Noncompliant Weld Inspection Techniques

Line 114 Non Destructive Examination Final Report

Issue Date December 5, 2013

Figure 2 - Weld 270 Indication with measurement inset showing length of 0.157" (3.9mm)

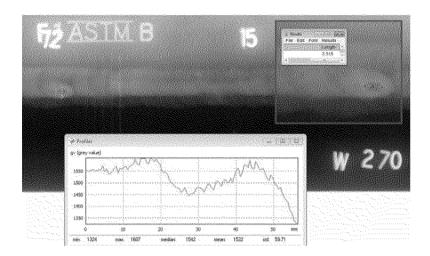
3.1 Weld 270, digitized in the region of interest is depicted in Figure 2. Here it can be seen, due to low change in density which is less than the adjacent parent material, and the presence of a halo, that the indication is one of Burn-Through (BT), and is acceptable per section 9.3.7 of API-1104. The weld repair process confirmed this result where the indication was found at the root.

Figure 3 – Weld 311 with acceptable BT length of 0.141" and acceptable small pores

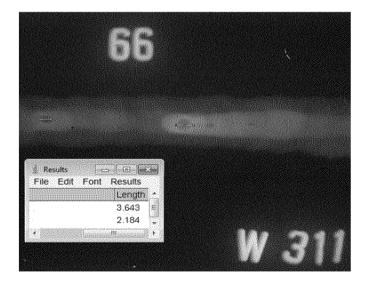
3.2 Weld 311, digitized in the region of interest, is depicted in Figure 3. Similarly we have one indication of burn-through and 3 small pores, all of which are acceptable per sections 9.3.7 & 9.3.9 of API 1104. For both welds 270 and 311, the repair process had to proceed to the root before the indications were eliminated, confirming that they were caused by burn through.

Figure 4 – Weld 162 with acceptable indications of undercut

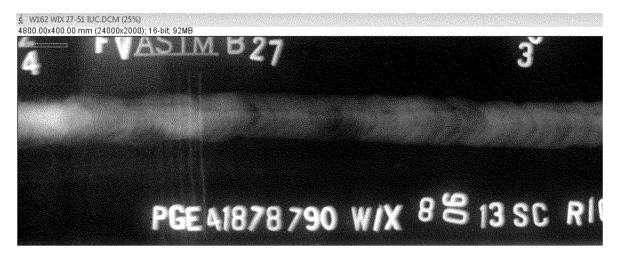
3.3 Weld 162 indication was digitized as shown below in Figure 4. Radiographic density measurements indicate that no portion of the indication has an indication of undercut which is greater than 0.016" deep, indicating that it is acceptable per section 9.3.11& 9.3.7 of API 1104.

Figure 5 – Measured IUC on W162 depicted in Figure 4

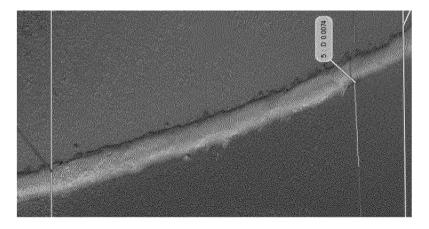
- 3.4 To validate the digital radiographic measurements, external visual, UC gaging and dial indicator measurements revealed that only small areas within the called ROI (25-29) had bottoms estimated below the adjacent parent material surface. Measurements had thus low repeatability due to topography. This result led to the decision for the Creaform photogrammetry with its calibrated 40 micron spatial resolution and accuracy to within 0.002".
- 3.5 Creaform photogrammetry results were obtained for the radiographic ROI (25-29 in Figure 4). The measurements confirm that no portion of the indicated area of concern radiographically, has a depth greater than 0.016 inches, and is therefore acceptable per sections 9.3.11 & 9.7. Figure 5 below depicts worst case of 0.0074" in radiographic ROI.

Figure 1 – Assessment of Weld 760 IUC region of interest

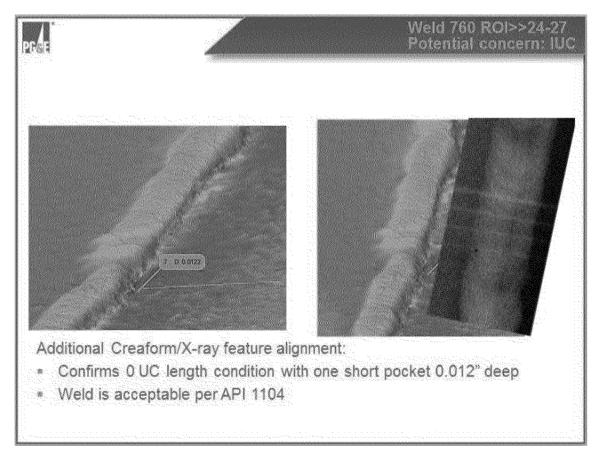
3.5 Creaform photogrammetry results were obtained for all the radiographic ROI's. The criteria applied to these results were API 1104 section 9.7, Table 4, "Maximum Dimensions of Undercutting". Applying the further criteria of depth from this requirement, to the documented radiographic and visual measurement data for length, all welds were found acceptable. Figure 2, from slide 5 in Appendix I, summarizes the typical physical condition for the audit identified indications of concern.

4.1 Against the requirements for undercutting contained in section 9.3.11, and section 9.7 of API 1104 twentieth edition, the findings of this report lead ATS to conclude that Welds 738, 760 770, 771, 781 of line 114 are acceptable.

Weld 760 ROI>>24-27 Potential concern: IUC

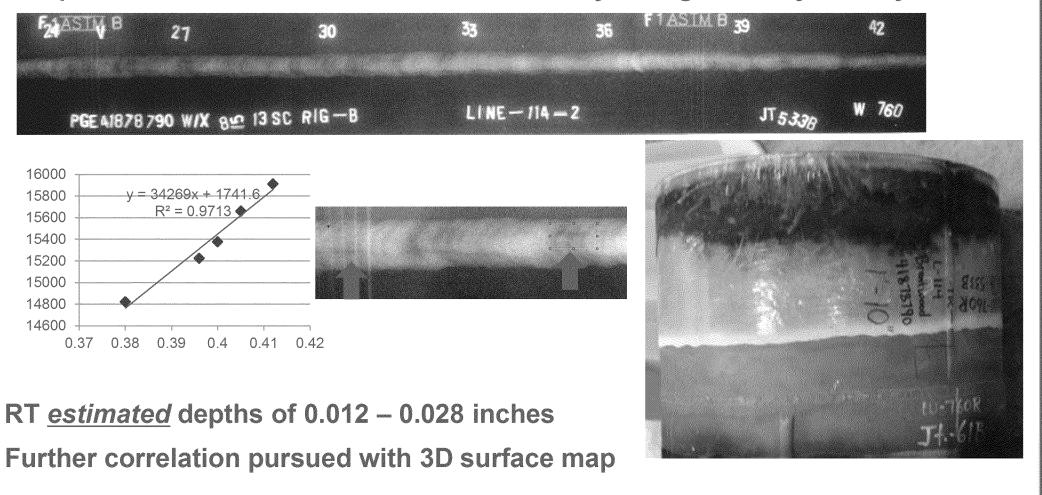
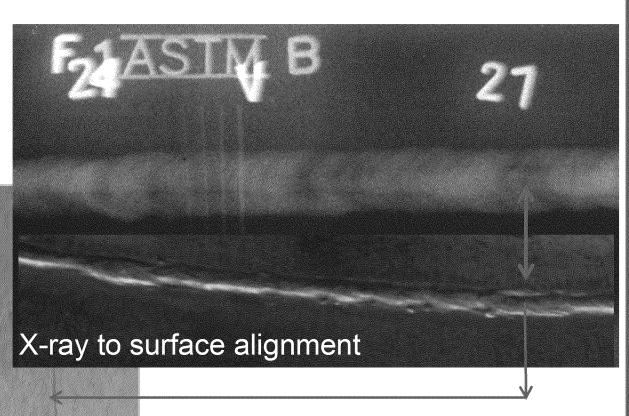
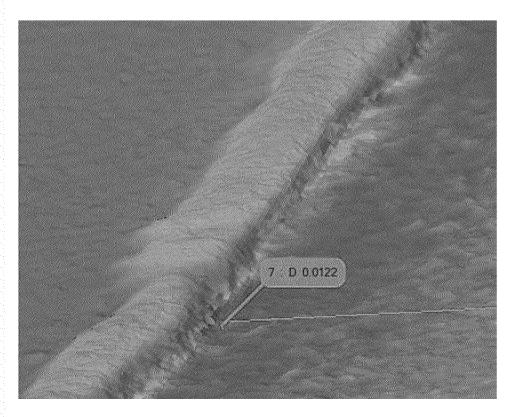
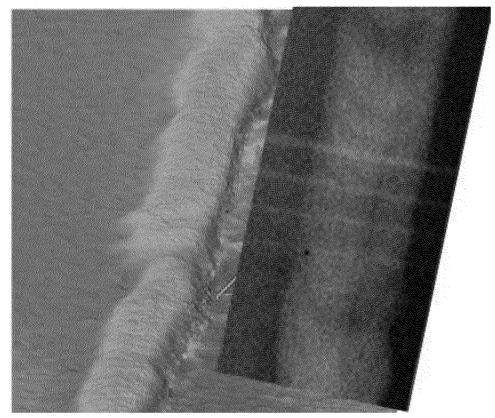
Weld 760 cited for indications of internal undercut from 24-27 Excised weld photo-documented and ROI aligned with weld features Depth of most severe indications estimated by change in x-ray density

- Confirms indications are mostly diffraction effects on minor hi/lo condition with 0 UC
 - Two small pockets are 12 and 28 mils deep with greatest length of 0.250"

- * Confirms 0 UC length condition with one short pocket 0.012" deep
- * Weld is acceptable per API 1104

Weld is acceptable per API 1104

Weld 770 cited for indications of internal undercut from 36-42 Excised weld photo-documented and ROI aligned with weld features Depth of most severe indications estimated by change in x-ray density

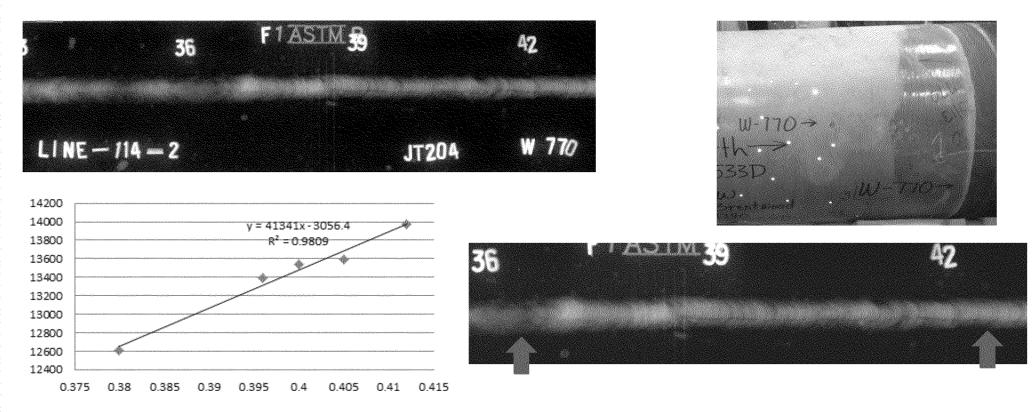
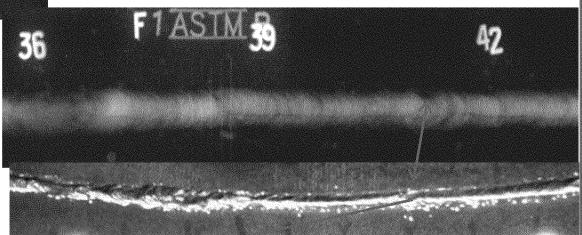
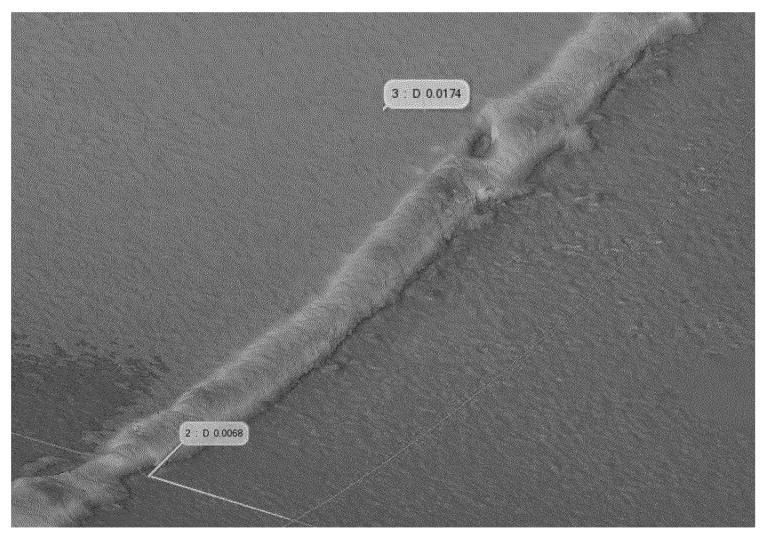
RT estimated depths of up to 0.008 inches

Confirms indications are, in the majority, diffraction effects on minor hi/lo condition with 0 UC

One small pocket observed at 0.007" deep x 0.130" long

- * Confirms UC indication is diffraction/"shadowing" from high/low condition
- * Weld is acceptable per API 1104

Weld 771 cited for indications of internal undercut from 12-24 Excised weld photo-documented and ROI aligned with weld features Depth of most severe indications estimated by change in x-ray density

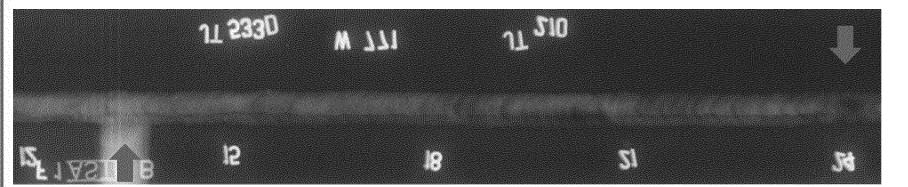
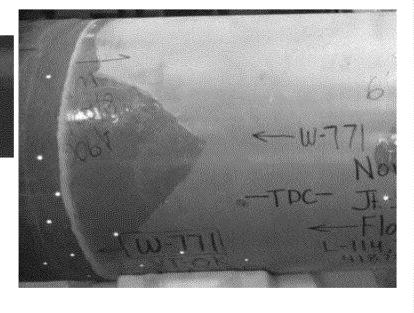
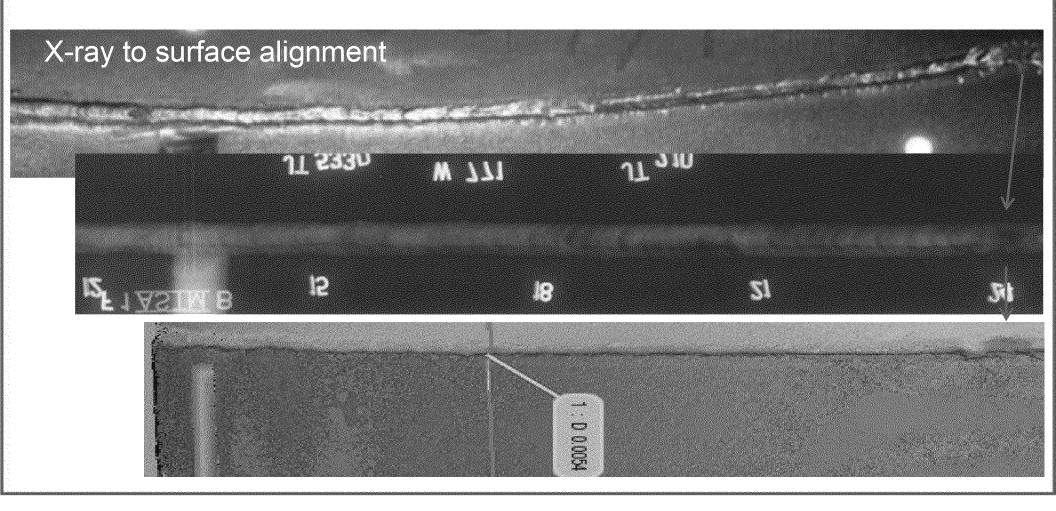
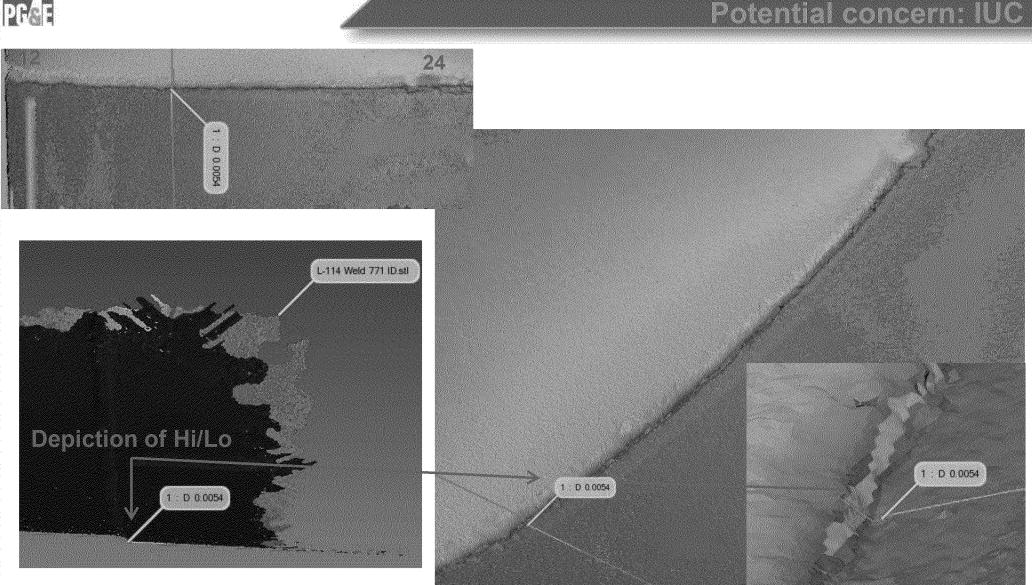
- Creaform 3D (+/- 0.002") surface profile:
 - Confirms indications are mostly diffraction effects on minor hi/lo condition with 0 UC
 - Deepest region along length is 0.006 inches
 - Weld is acceptable per API 1104

Weld 781 cited for indications of internal undercut from 44-49 Excised weld photo-documented and ROI aligned with weld features Depth of most severe indications estimated by change in x-ray density

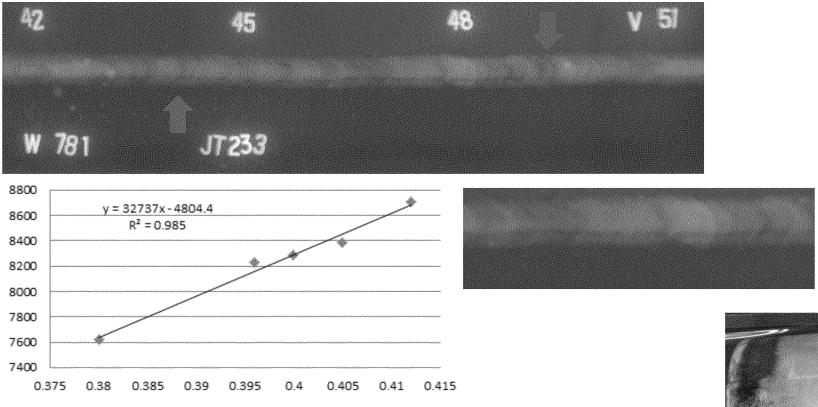
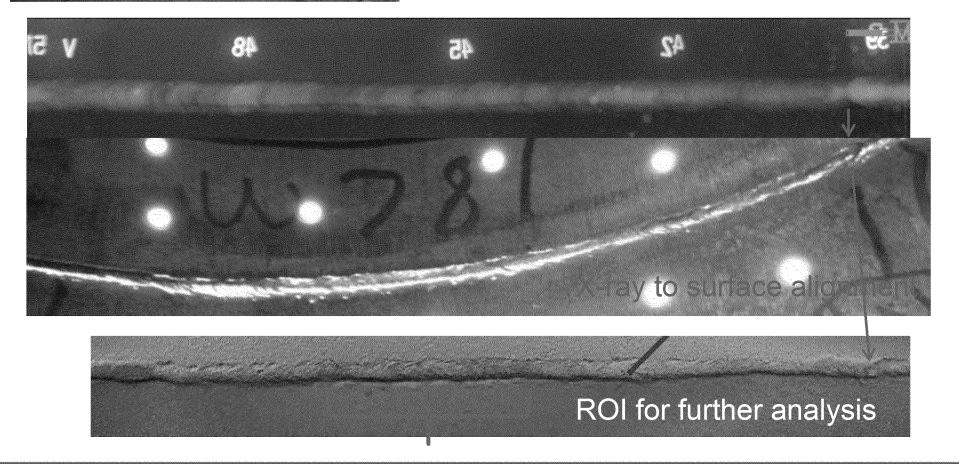
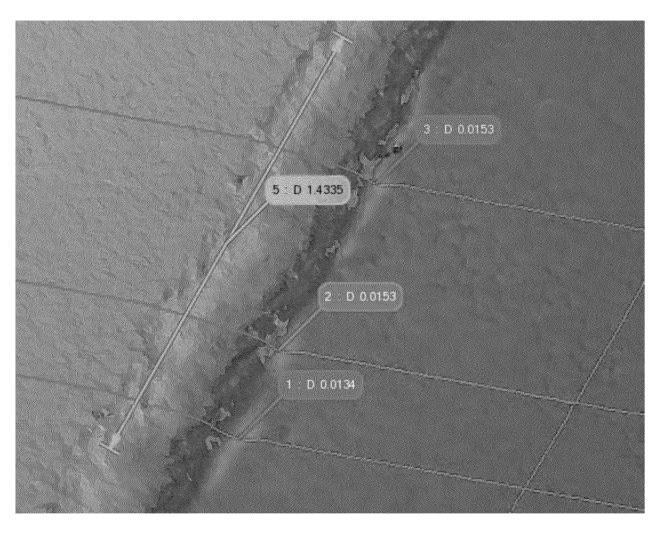
- Confirms indications are mostly diffraction effects on minor hi/lo condition with 0 UC
 - Largest region is 1.5 long x up to 0.015 inches deep
- Weld is acceptable per API 1104

- * Confirms UC indication is, in the majority, diffraction/"shadowing" from high/low condition with less than 2 inches of up to 0.015 inches deep IUC
- * Weld is acceptable per API 1104

Weld 738 ROI>>36-42 Potential concern: EUC

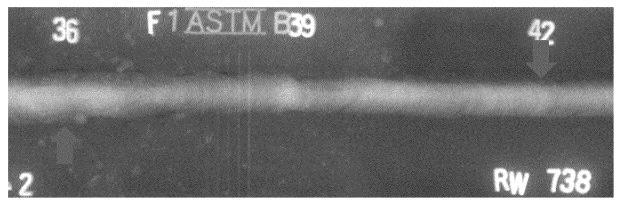
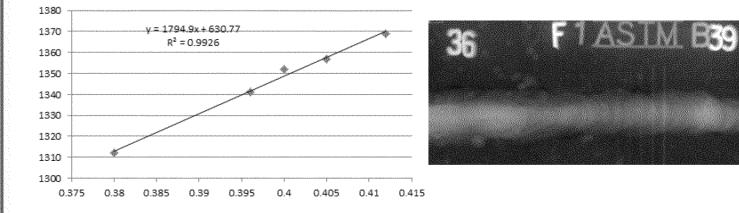
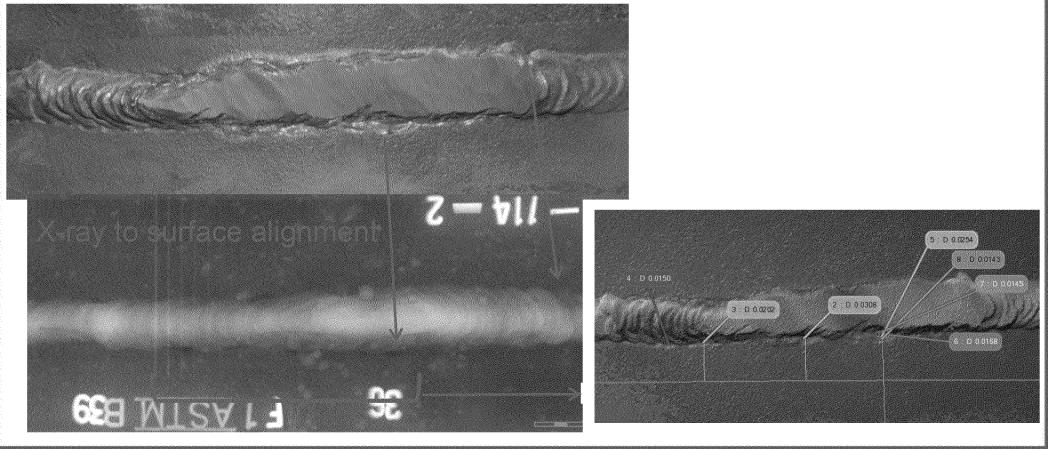
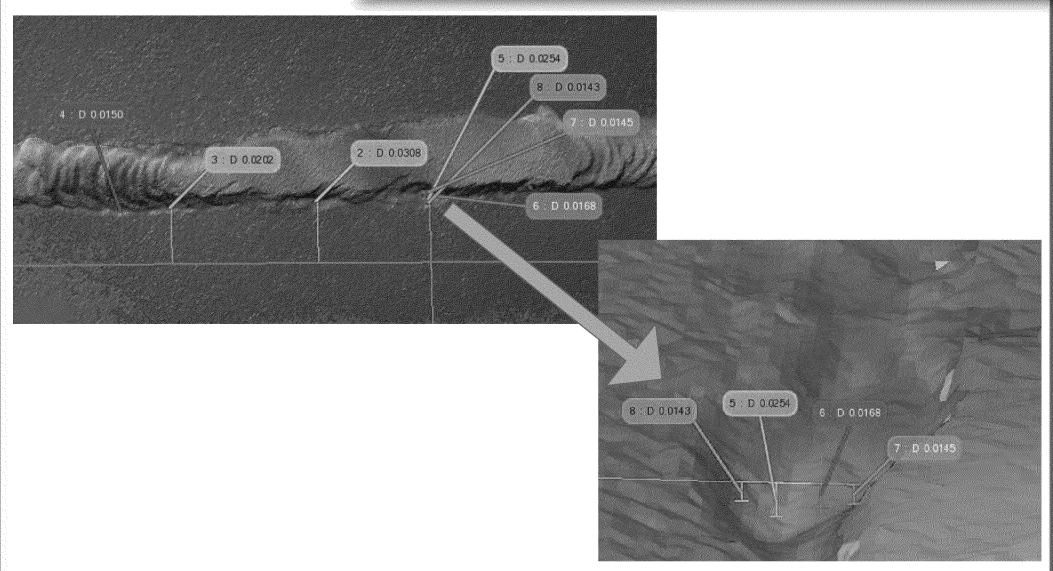
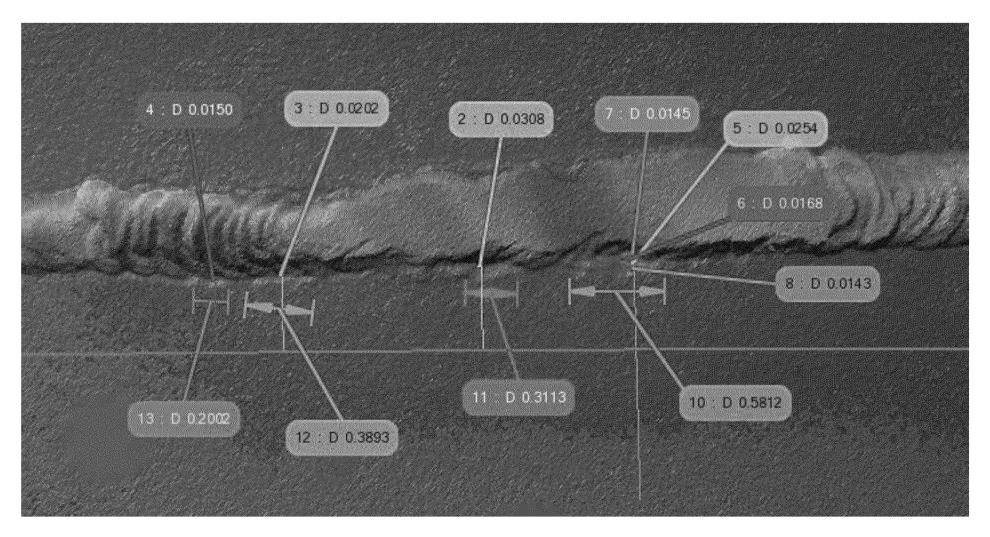
Weld 738 cited for indications of external undercut from 36-42 Excised weld photo-documented and ROI aligned with weld features Depth of most severe indications estimated by change in x-ray density

- Creaform 3D (+/- 0.002") surface profile:
 - External undercut identified up to 0.030" deep
 - Sum of UC lengths < 1.5"
 - Weld is acceptable per API 1104

- * EUC noted in several short segments totaling less than 1.5"
- * Weld is acceptable per API 1104
